Title		Last Edited:	
Laser Current Driver		LIGO Laboratory California Institute of Technology Massachusetts Institute of Technology	
Size: C	DCC Number: D1200719	SCH / PCB Revision: V5	Engineer: R.S. Abbott
File: C:\Richy\Files\Mycad\laser_R_and_D\Laser_current_driver\Laser_Driver_v5.SchDoc		Date: 3/22/2016	Time: 10:05:08 AM
		Sheet 1 of 2

D1200719-v5
High Stability, Low Noise
Laser Current Driver

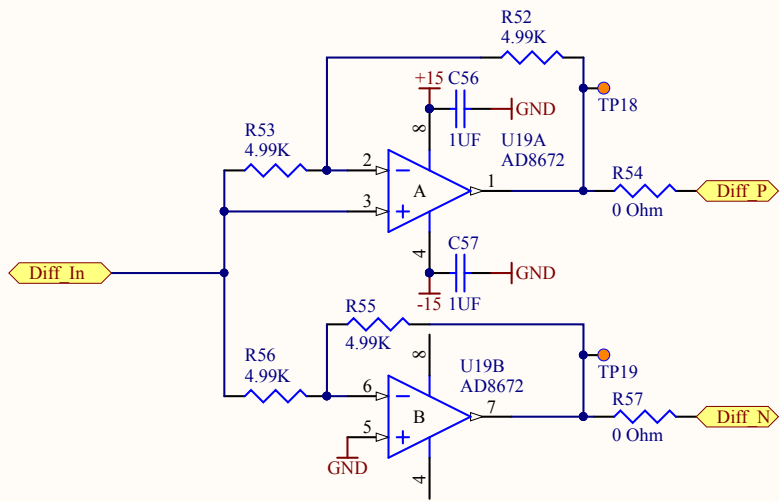
- Revisions and Modifications for version 5:
1. Used shorter heat sinks for regulators so it will fit in a 1U chassis
 2. Ensured voltage reference is a 10V part. The bill of materials had this at 5V

3. R42 changed from 750 to 2.21k to provide about 15VDC regulated power for the laser diode
 4. Added a 499k resistor to pick up the Vref connection, thus improving the accuracy of the current monitor.

5. Put a FET back onto the base drive of the main current modulator to eliminate base current error.
 6. Changed R44 to 10k to make current readout more reasonable.

7. Diode protection of U9 by back-to-back diodes across positive and negative inputs
 8. Change C14 from 68pF to 27pF for less compensation of the AD829

9. Add provision to drive the chassis rear panel LEDs for +15VDC
 10. Change C39 to 100pF
 11. Change C25 to from 10uF to 1uF, should update footprint to leaded plastic capacitor

12. Q1 E-B Backwards on PCB
 13. Change R31 from 100 to 50 ohms to increase the current range
 14. Added protection diode to Q1 base (D12)
